I-285@ CR 4519/Atlanta Road

GDOT Project Number: STP00-0222-01(001), P.I. No. 752300

Value Engineering Study Report

June 2009

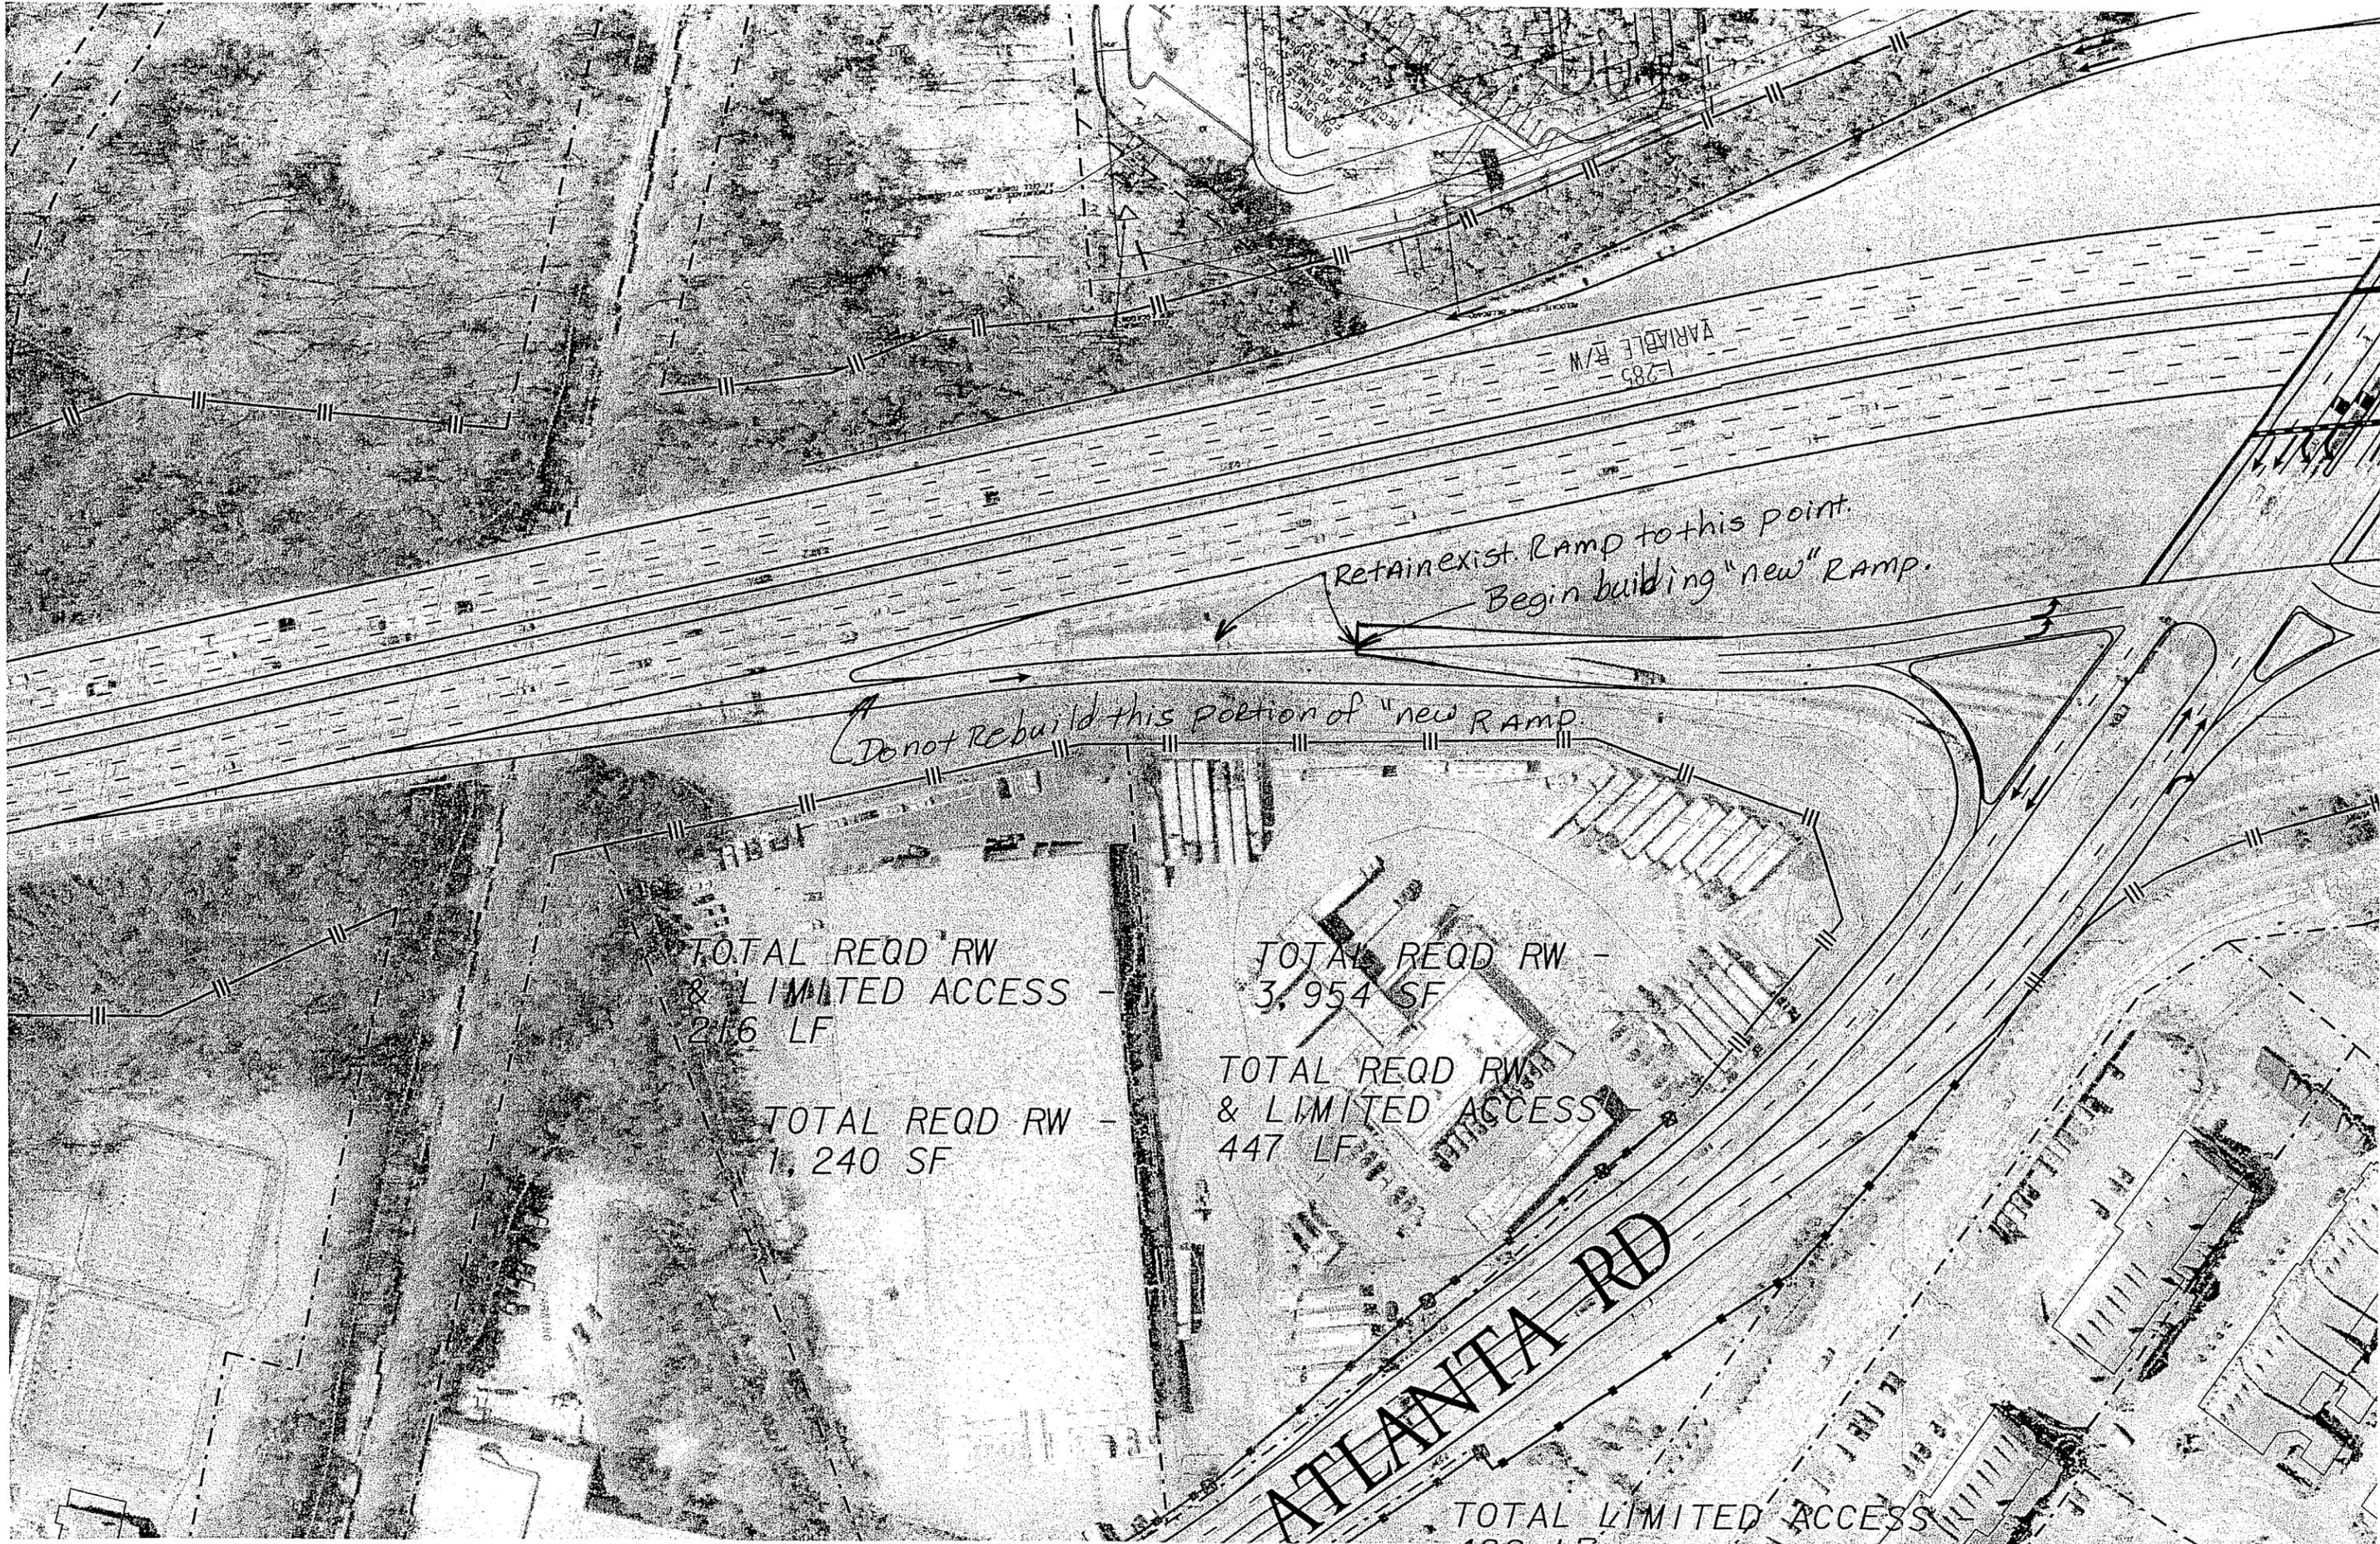
The existing deceleration lane for the northbound exit ramp is an acceptable design and could be retained. Save this portion of the ramp since it will be replaced under the future expansion of I-285 anyway. Any redesign of the ramp in the vicinity of I-285 will be obsolete in the future. The portion to be retained is concrete pavement
